NASA Engineering and Safety Center Technical Assessment Report	Document #: RP-06-01	Version: 1.0
Title: External Tank Liquid Hydrogen (LH₂) Prepress Regression Analysis Independent Review Technical Consultation Report			Page #: 1 of 34

External Tank Liquid Hydrogen (LH₂) Prepress Regression Analysis Independent Review Technical Consultation Report

The NESC team performed an independent review of regression models documented in *Prepress Regression Analysis*, Tom Clark and Angela Krenn, 10/27/05. These regressions were developed for determining the expected cycle count described in LCC ET-04. This independent review was limited to regression models developed based on variable measurements that are available prior to launch and corresponding to the development of “regression #1”, pp 4-7, in *Prepress Regression Analysis*.

Figure 7.0-1. Comparison of Elevated Cycle Counts Resulting from Incorrect Diffuser Material on Three STS-114 Tanking Tests with Cycle Counts for the Remaining Data Records

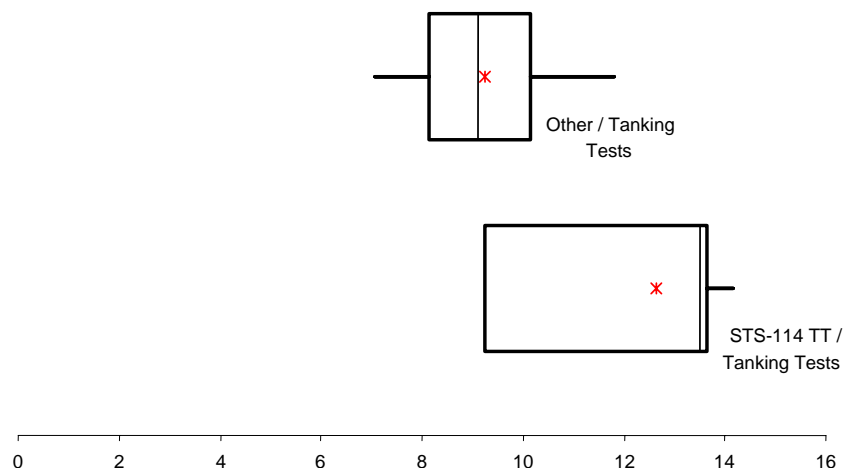
All three tanking tests for STS-114 yielded large cycle counts resulting from a known anomaly caused by use of an out-of-specification material (Double Dutch Twill) for diffusers. This anomaly is illustrated in the box plot in Figure 7.0-1. Appendix B provides a key for interpreting box plots.

Figure 7.0-2. Comparison of Elevated Cycle Counts Resulting from Undersized Orifice on MLP-2 with Cycle Counts for the Remaining Data Records

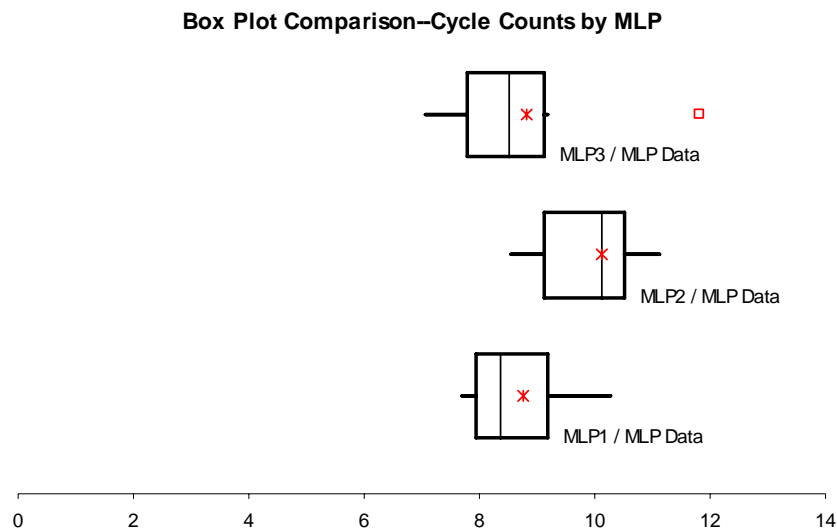
Additionally, the set of eight launches using MLP-2 (STS-95, -96, -98, -103, -104, -106, -109, and -113) have larger cycle counts, resulting from a known anomaly caused by a restrictive upstream orifice. This anomaly is illustrated in the box plot in Figure 7.0-2 (where the anomalous STS-114 tanking tests have been removed from the data set).

The causes of these anomalous cases have been corrected and are unlikely to be repeated.

Figure 7.0-3. Scatterplot of the fit versus actual cycle count for the regression on all variables

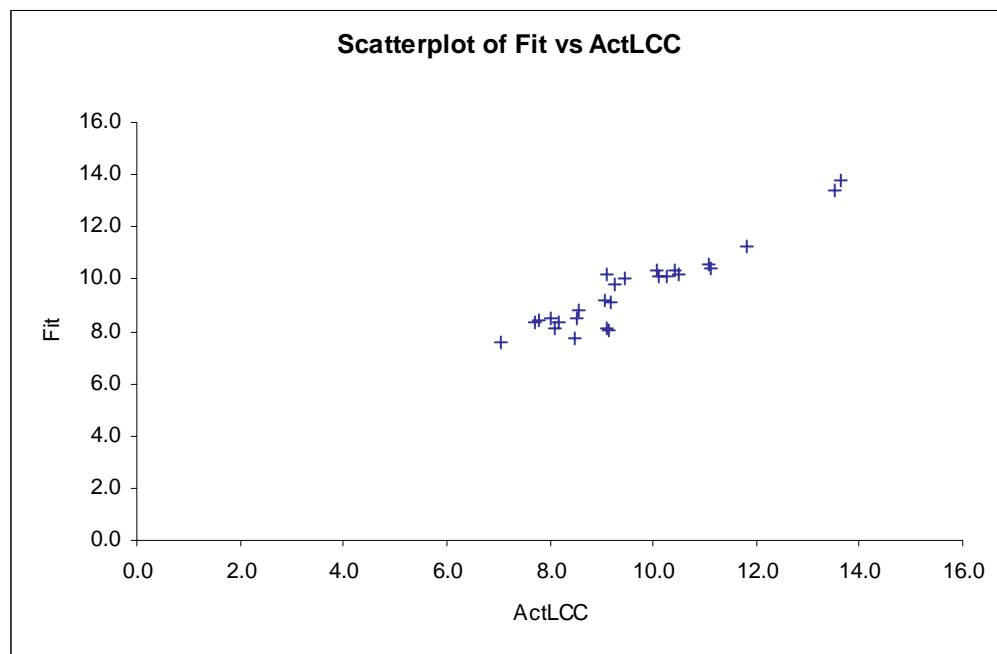
The scatterplot of the fit versus the actual cycle count output in Figure 7.0-3 confirms that the residuals appear to be random and that the linear model correctly captures the relationships in the data.

Figure 7.0-4. Scatterplot of the Fit Versus Scaled Actual Cycle Count for the Regression on all Variables

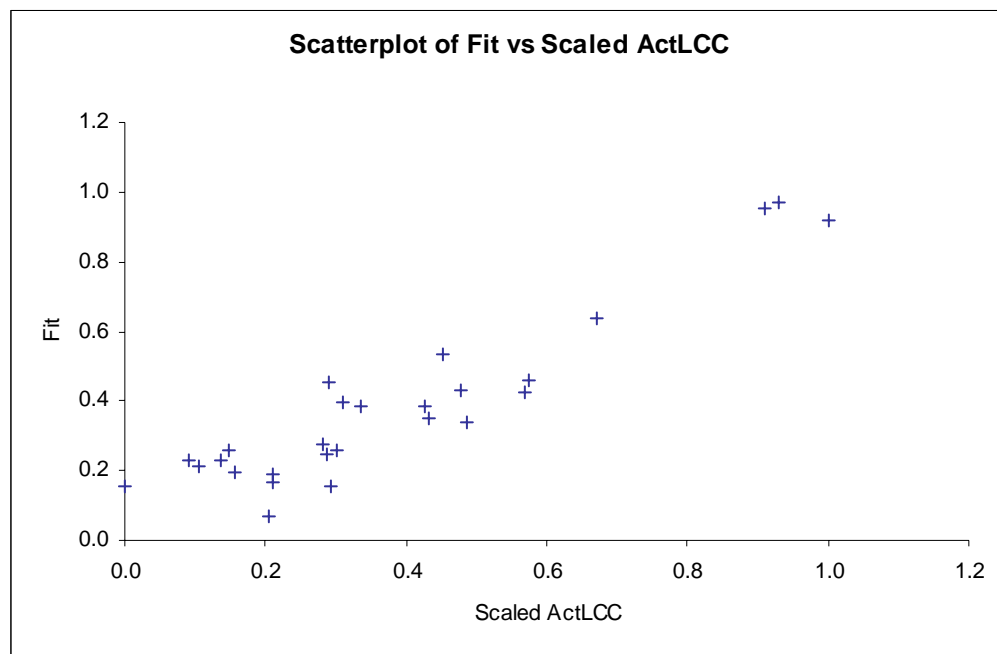
The scatterplot of the fit versus the actual cycle count output shown in Figure 7.0-4 confirms that the residuals appear to be random and that the linear model correctly captures the relationships in the data.

Figure 7.0-5. Comparison of Scaled Output and Predictor Variables for the Clark and Kreen Comparison

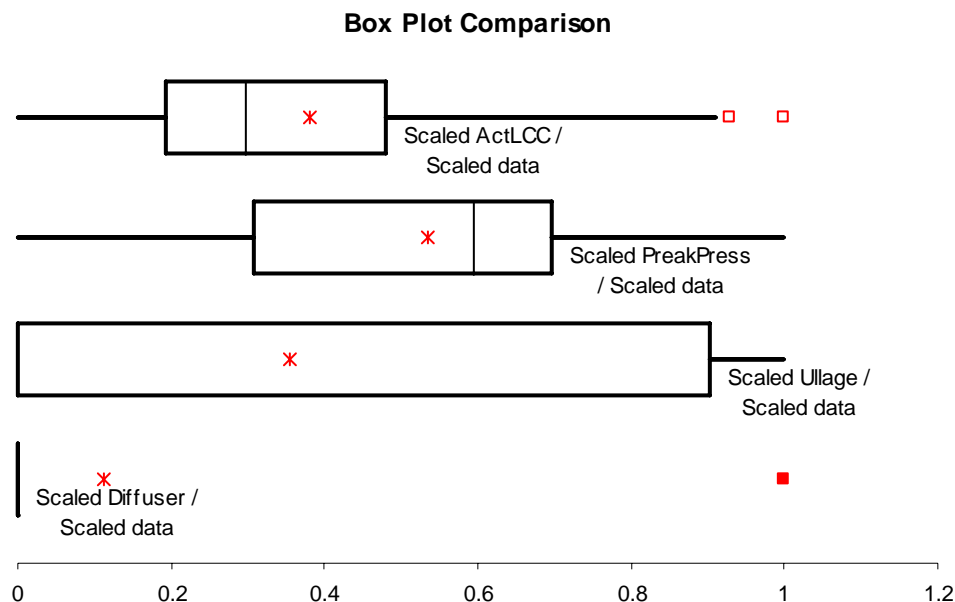
Scaling the data also permits box plots for all of the variables and variable interactions in the regression on the same scale, as shown in Figure 7.0-5. The data anomalies previously described are clearly reflected in the outliers in these plots.
